FCC ID: 2ALEPT0004438

PCBA Comparison

Change List:

Figure 1 Gen 2 Fixed gateway primary side

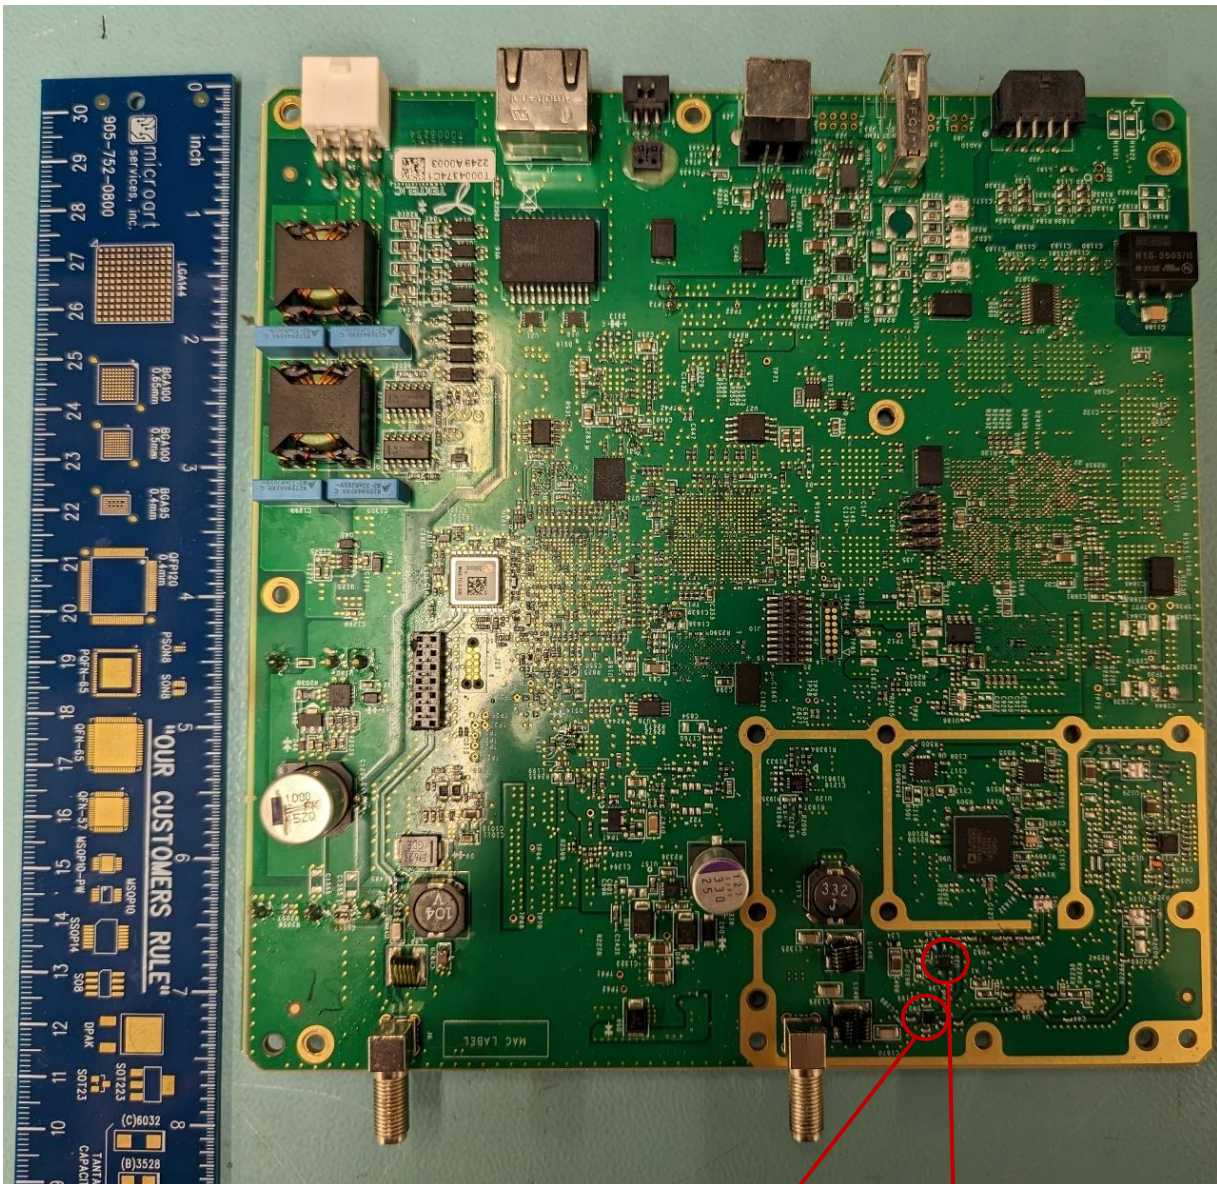
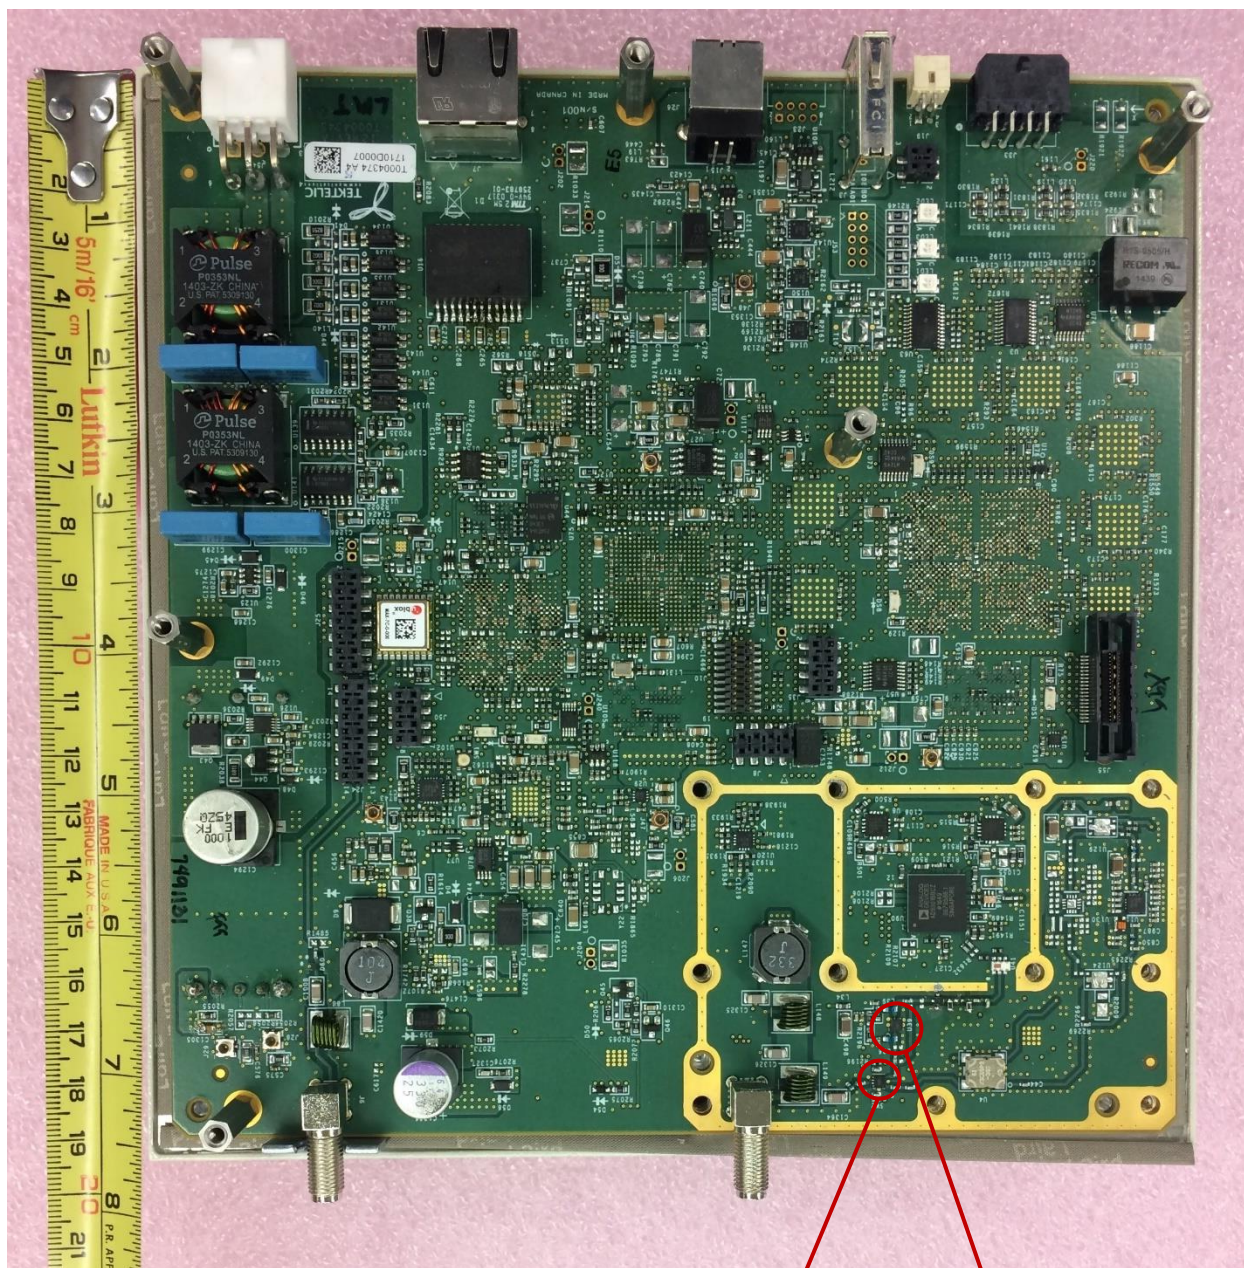
RF SPDT switch
RFSW8000

LNA
Qorvo TQP3M9036

RF SPDT switch
SKY13321

LNA
Avago MGA-633P8

Figure 3 Gen 2 fixed gateway secondary side

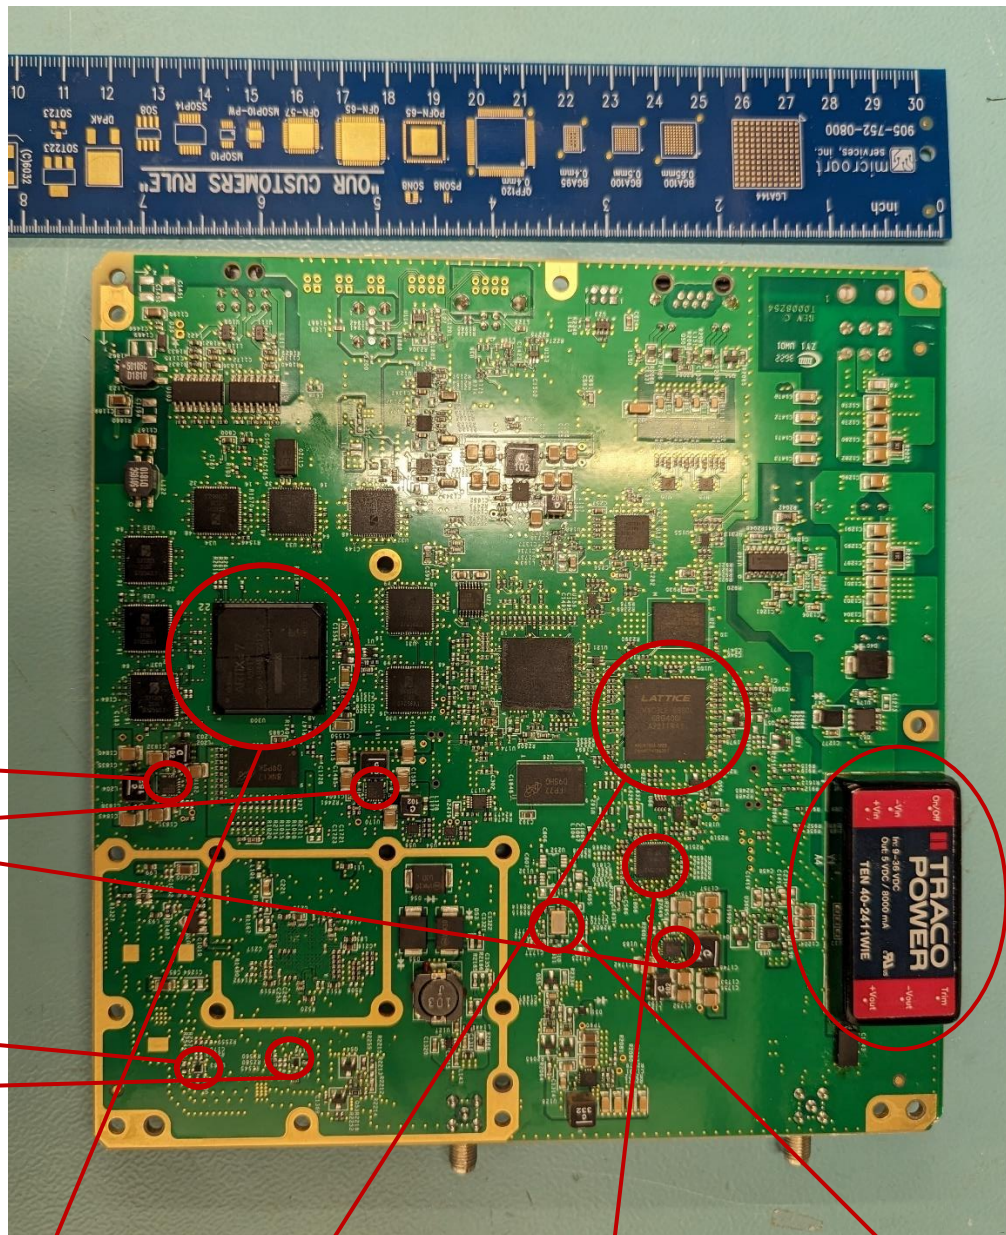
Buck power
converter
MAX20408AF0C

Detector for
VSWR
LMH2100

Power
supply
Traco TEN
40-2411

FE FPGA
Artix-7

GPIO FPGA
Lattice MachXO3LF

Clock generator
TI CDCM6208

Crystal oscillator
SiT5156AI
